#### **ADDENDUM NO. 01**

# SUWANNEE PRIMARY SCHOOL COVERED PLAY STRUCTURE and

# I.T &TRANSPORTATION BUILDING (SHELL STRUCTURE) for the

A/E# 2012.51A & 2013.46A

### IT & TRANSPORTATION BUILDING - SITE SKETCH

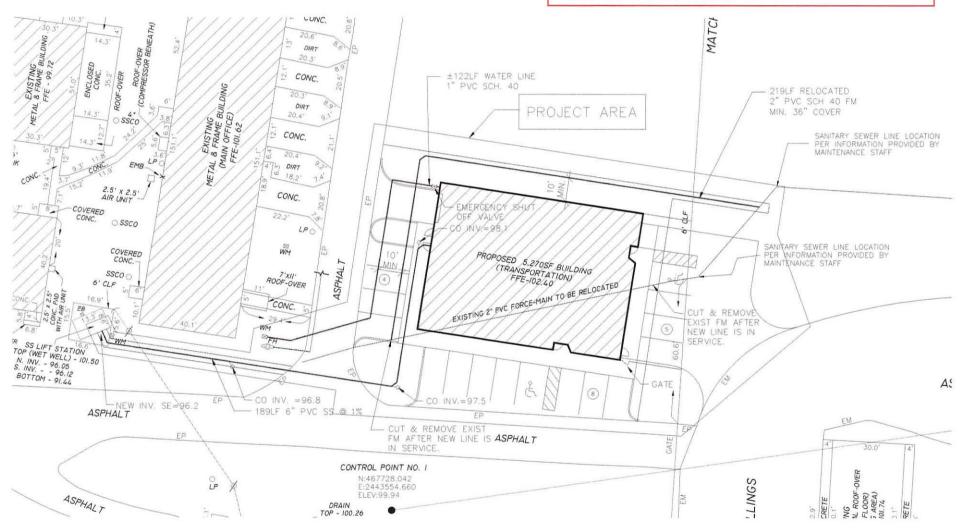
- C. SITE PLAN: A formal site plan is not available at this time; however, attached is a preliminary plan which shows the slab elevation and location of utilities (for information only). The site work will be performed by the SCSB maintenance staff, by a separate contractor or may be considered as additional work for the lowest responsible bidder. The site will be rough graded to the slab bottom elevation by the SCSB and the low bidder will be responsible for the compaction thereof and notifying the owner's testing company to undertake testing and issue

test reports. The contractor may begin work on the slab, foundations and under slab utilities and shall assure appropriate compaction is obtained and confirmed via testing on all disturbed locations in the area of the work prior to pouring any concrete.

This plan is to be used by the contractor for the finish floor elevation. The utilities and other data are shown for information such that the contractor is aware of the proposed future site work for coordination of his efforts to accommodate same.
